Response to reviewer #1

1. Original manuscript (title): “Ambient methane monitoring at Hohenpeißenberg utilizing photoacoustic spectroscopy and cavity ring down spectroscopy”

Fig. 11. Measured photoacoustic magnitude (black squares, upper graph) and phase shift ϕ (red triangles, lower graph) for 15 ppmV methane diluted in a nitrogen, oxygen mixture with rising humidity content. The calculation results obtained from CoNRad are represented by solid lines.

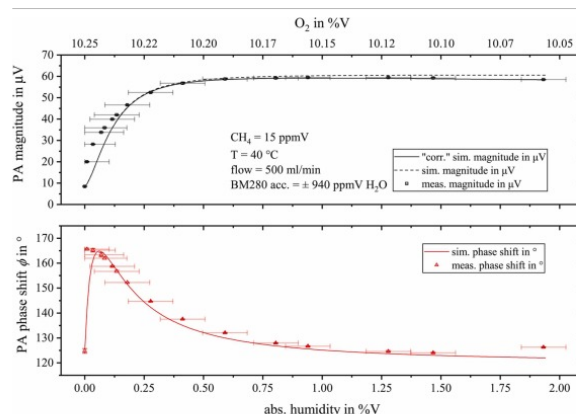
11. Original manuscript (line 106): “In order to enhance the humidity during target gas operation and thus increase the generated PA signal”

-Reviewer: **was the humidifier always in operation, also for the stream of ambient air? If not, how it was switched on and of, complete the picture please or place a comment**

The humidifier was always in operation. The simulation output of CoNRad for slightly humidified “air-like” gas samples ($\text{H}_2\text{O} < 0.25\% \text{V}$) shows lower confidence in simulation output compared to the measured data, refer to Figure 11 – (<https://doi.org/10.1016/j.pacs.2022.100371>).

To avoid this problem we additionally humidified the gas sample by about 0.3%V.

To make this point clearer we rephrased: “In order to enhance the humidity during target gas operation and thus increase the generated PA signal by minimizing the influence of relaxation effects a self-developed humidity generator was installed upstream of the PA sensor (Müller et al., 2022).” to “As the difference between the theoretical calculations of CoNRad and the measured data is highest for only slightly humidified measuring environments ($\text{H}_2\text{O} < 0.25\% \text{V}$), see Figure 11 from Müller et al. (2022), an additional humidification of the sample gases of about 0.3 %V was chosen to avoid this issue. This was realized by a humidity generator installed up-stream of the PA sensor.”
